CITY OF ALBUQUERQUE

**Re: Signal Pointe Subdivision
Signal/Ventura
Grading and Drainage
Engineers Stamp Date 9/15/2015 (C20D070)**

Based upon the information provided in your submittal received with Engineer's Stamp Date 9/15/2015, the above referenced Grading and Drainage Plan is approved based on the following conditions:

GRADING & DRAINAGE PLAN

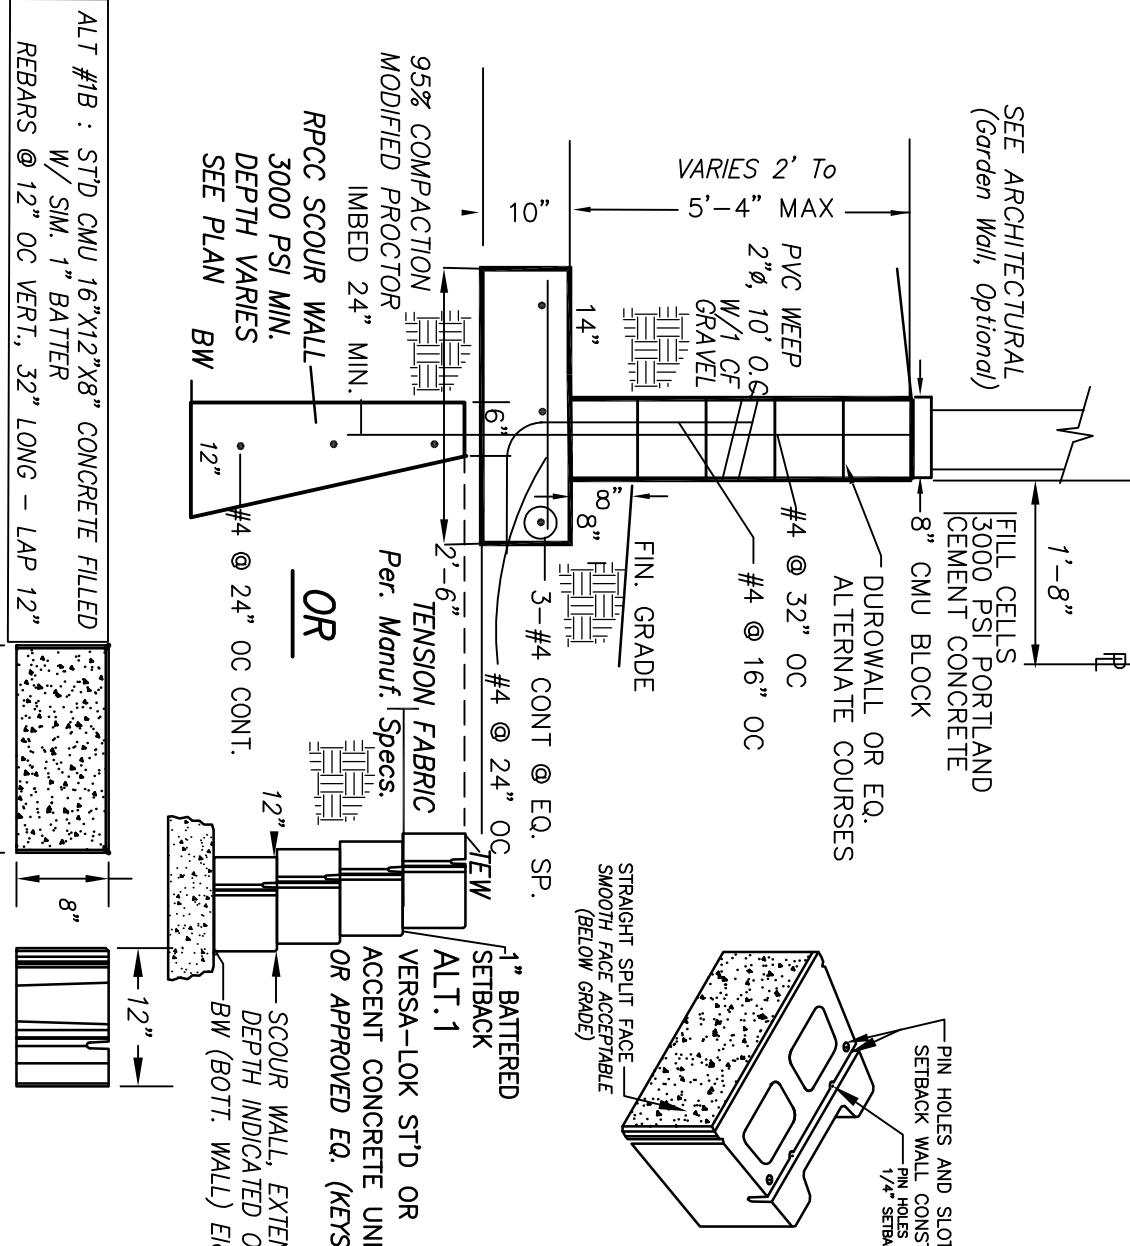
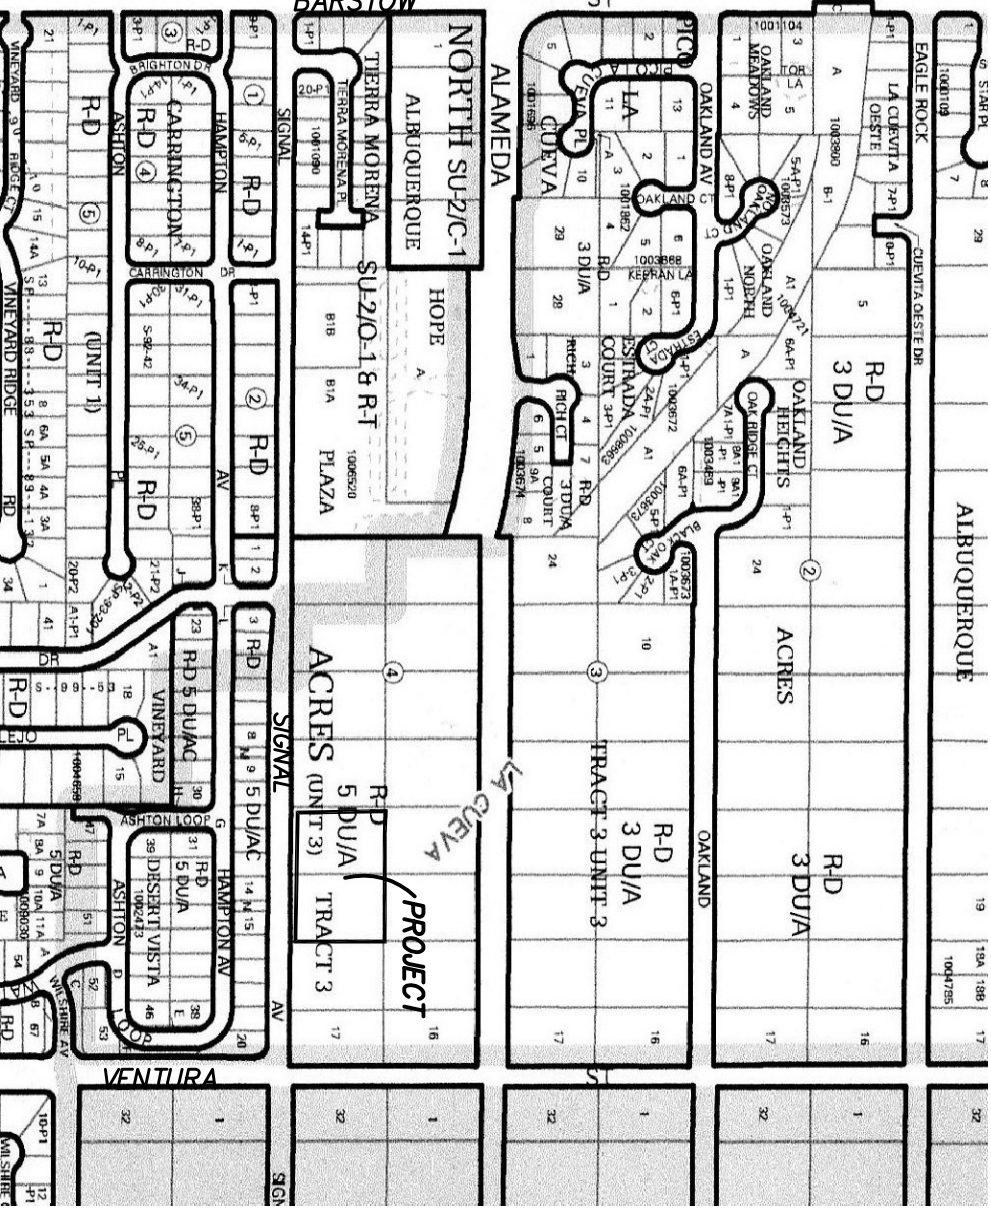
- The wall should remain in place once the erosion occurs. Please design the flood control structures accordingly. The wall detail/calculations/specifications must be clearly shown on the DRC plans.
- Provide plan and profile sheets for the flood control structure including the top and bottom elevations and Stationing.
- Grading Certification will be required prior to release of Financial Guarantee, Workorder and building permits.
